**AMENDMENT NO. 1 DECEMBER 2007
TO
IS 13047:1991 METHOD FOR DETERMINATION
OF STRENGTH OF ROCK MATERIALS IN
TRIAxIAL COMPRESSION**

FIG 3 STRENGTH ENVELOPE

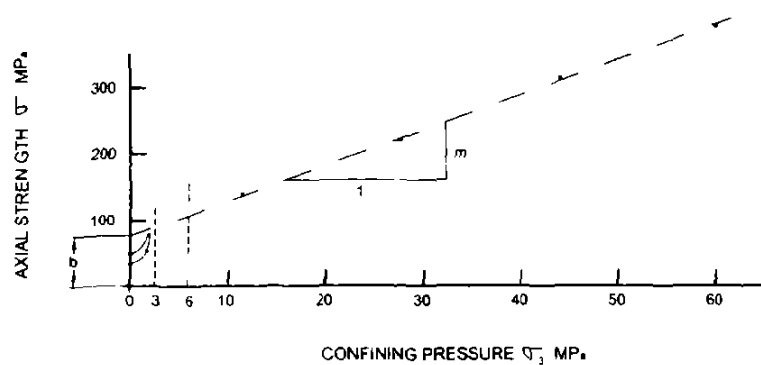
(Page 3, Fig 3) — Substitute following for the existing figure
